Access Compliance Report

Public Rights-of-Way

(Curb Ramps)

Intersection ID: 18496	Main Street: MICHAEL_BAKER_PL	Cross Street: SELWYN_AV	Location: NE
ADA ID: 5C1C0A9876C9	Ramp Type: Perp	Initial Pass/Fail: Fail	Overall Compliance: No
Severity Score: 58.75			
Codes/Mitigation Info/Possible Solution		Field Measurements/Component Compliance

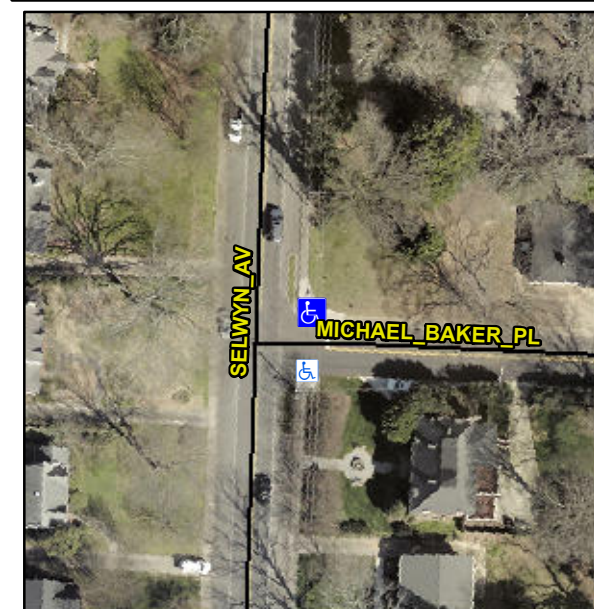
R304.5.1, R304.5.3

Compliance	Description	Data	Compliance	Description	Data
N/A	Ramp Length (in)	267.0	Yes	Ramp Slope (%)	12.7
No	Ramp Width (in)	47.0	No	Ramp XSlope (%)	8.8
N/A	Flare Type LT	N/A	N/A	Flare Type RT	N/A
N/A	Flare Slope LT (%)	N/A	N/A	Flare Slope RT (%)	N/A
N/A	Flare Traversable LT?	N/A	N/A	Flare Traversable RT?	N/A
N/A	Landing Length (in)	N/A	N/A	DWS Provided?	N/A
N/A	Landing Width (in)	N/A	N/A	DWS Contrast?	N/A
N/A	Landing Slope (%)	N/A	N/A	DWS Length (in)	N/A
N/A	Landing X Slope (%)	N/A	N/A	DWS Full Width?	N/A
N/A	Landing Curb? (Y/N)	N/A	N/A	DWS Offset (in)	N/A
N/A	Shared Landing?	N/A			
N/A	Gutter Ponding?	N/A	N/A	Gutter Slope (%)	N/A
N/A	Gutter Lip Ht (in)	N/A	N/A	Gutter X Slope (%)	N/A
N/A	Painted X Walk1?	No	N/A	Painted X Walk2?	N/A
	X Walk 1 Direction	To SW		X Walk 2 Direction	N/A
N/A	X Walk 1 Width (in)	N/A	N/A	X Walk 2 Width (in)	N/A
	X Walk 1 Slope (%)	4.1		X Walk 2 Slope (%)	N/A
	X Walk 1 X Slope (%)	7.3		X Walk 2 X Slope (%)	N/A

Remove & Replace Entire Ramp.
